DETENT BALL REPLACEMENT

EFFECTED TRANSMISSIONS

SERIAL # T7300 TO SERIAL # T7435

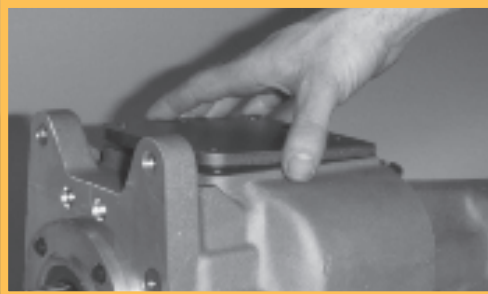
1. Install both detent balls and springs into case detent holes as shown before installing side cover.

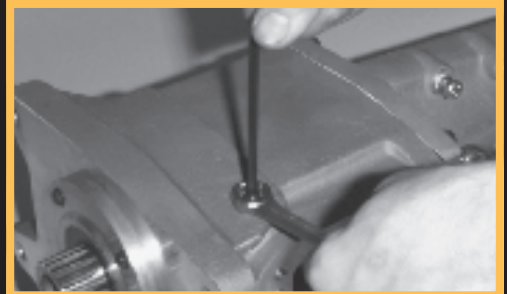
2. Side cover installation. Make sure gasket is in place and detent springs and balls are in their proper places. Torque side plate bolts to 15 ft lbs.

3. After installing detent ball and detent spring, install detent screw and jam nut. This is your high gear (direct drive) detent adjustment. This adjustment allows for varying degrees of high gear retention. Factory setting is 1/2 turn off from bottom. Do not use excessive force to find bottom.

PLEASE NOTE: It may be necessary to deburr, by hand, the detent bores with a 5/16" drill bit.
